DRAINAGE LETTER
for
THE COMMONS AT FALCON FIELD - STOCKPILE

El Paso County, Colorado

December 2024

CDR2411

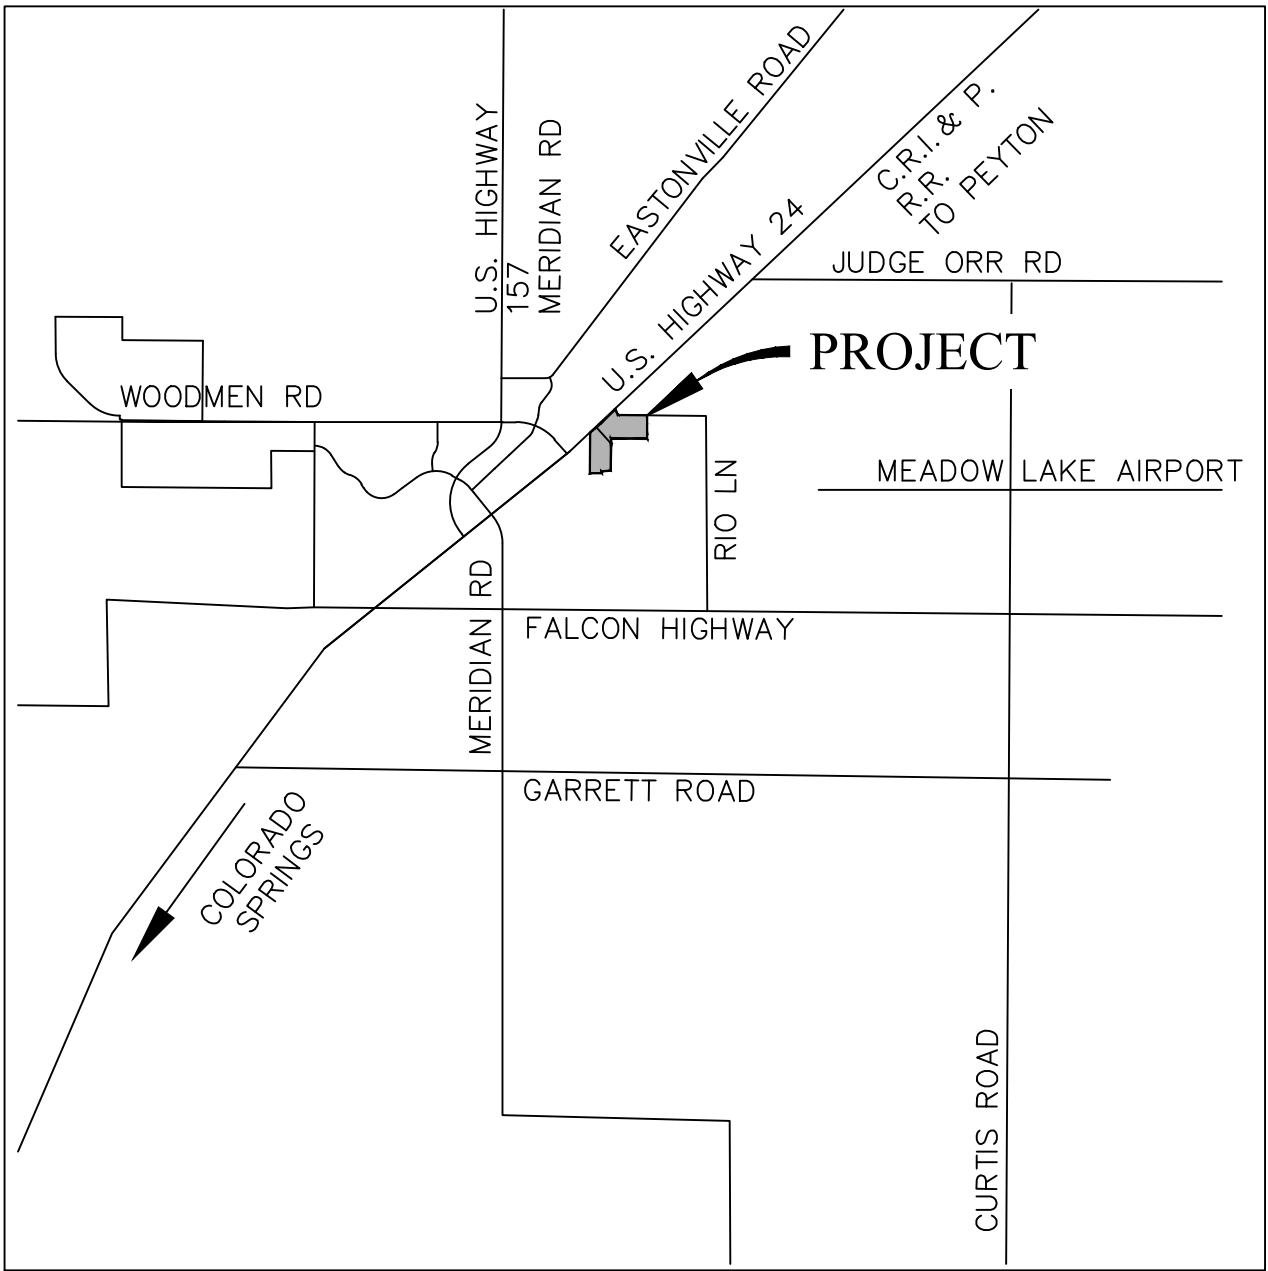
other than vehicles crossing the floodplain will any disturbance be done to or near the floodplain? please clarify and show if any grading is to be done.

Please consider moving the stock pile area away from the property lines. One concern is diversion swales around the stockpiles that may concentrate flows onto the adjacent property. Please be sure to address the diversion swales as indicated by stormwater comments.

please address any outfalls from the TSB's and ensure that the outfall is not on the adjacent property nor adversely affects the adjacent property due to the concentrated flows (i.e. suitable outfall)

See comments on GEC plan and discuss TSBs and/or diversion swales. Diversion swales should be adequately sized for the flows that are tributary to them.
